2006 IBC Structural/Seismic Design Manual, Volume 1

Errata Changes to First Printing. This errata supersedes all previous errata.

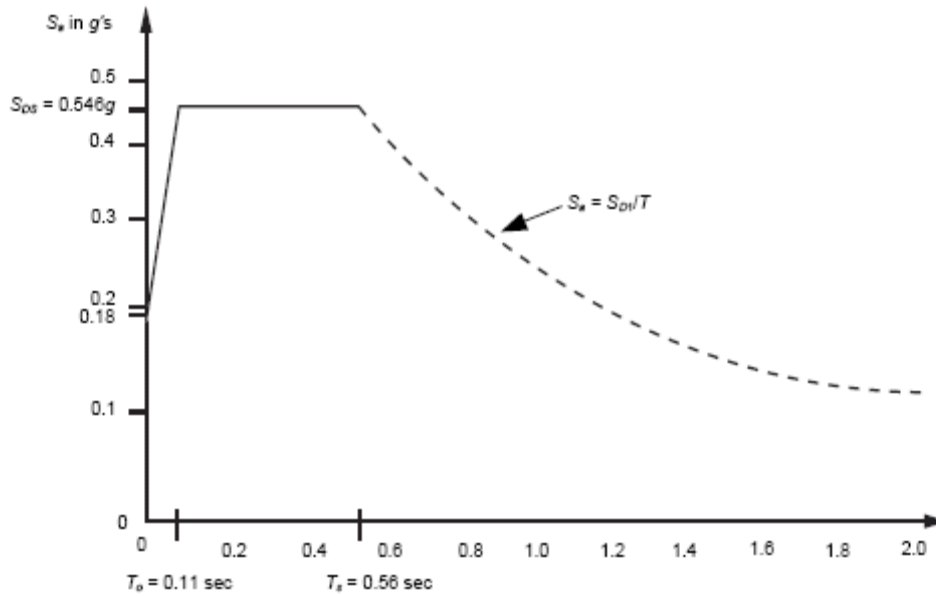
Page 38 Number 4 Equation 11.4-6 should read:

$$S_a = (S_{D1}) / T \quad (\text{Eq 11.4-6})$$

Where: $T_o = 0.20 (S_{D1} / S_{D5})$
 $= 0.2 (0.305 / 0.546)$
 $= 0.11 \text{ sec}$

$$T_s = S_{D1} / S_{D5}$$
$$= 0.305 / 0.546$$
$$= 0.56 \text{ sec}$$

Figure 15-2

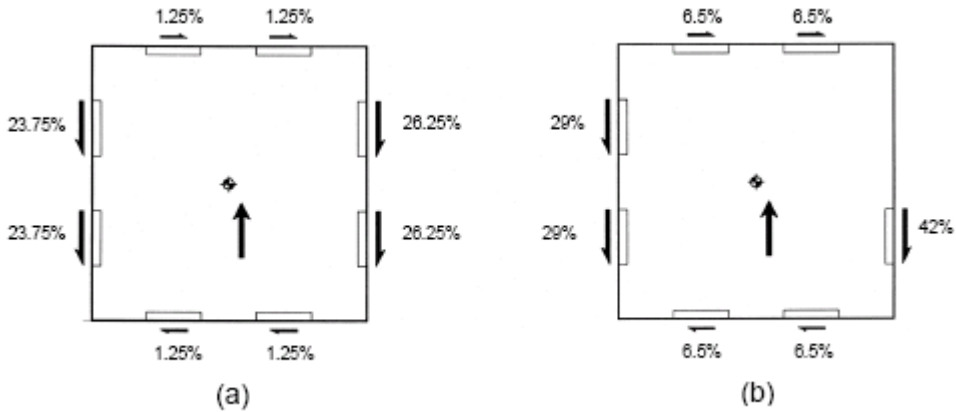
Page 72, top of page Figure 15-2 should read:

Figure 15-3

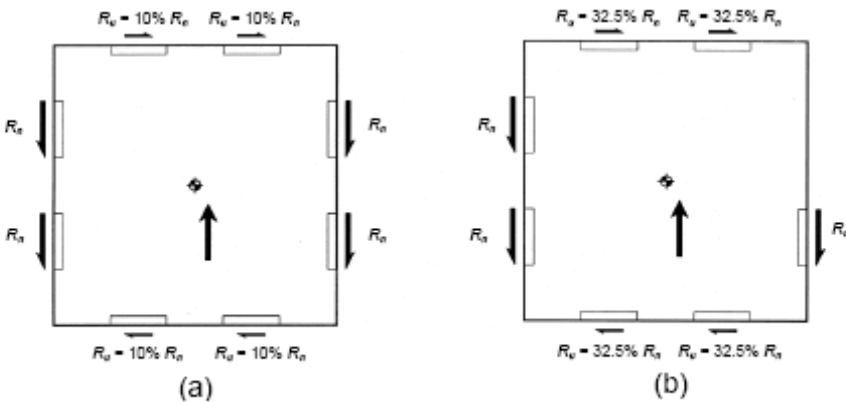
Page 72, bottom of page Figure 15-3 should read:

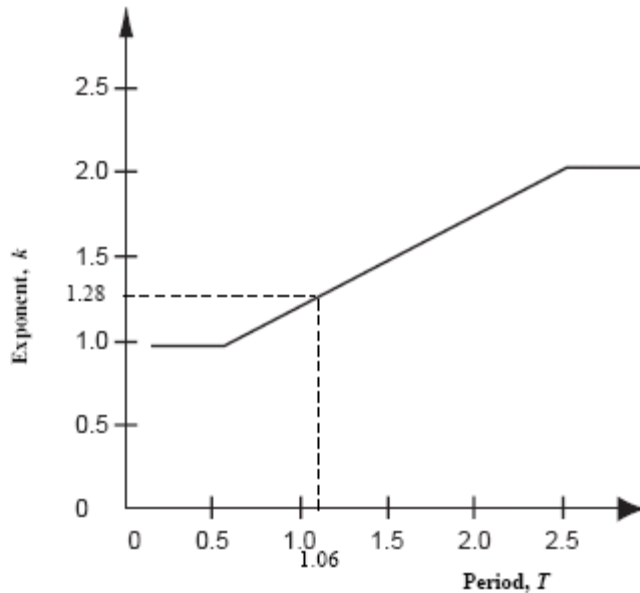
Page 94, Number 3 bottom figure should read:
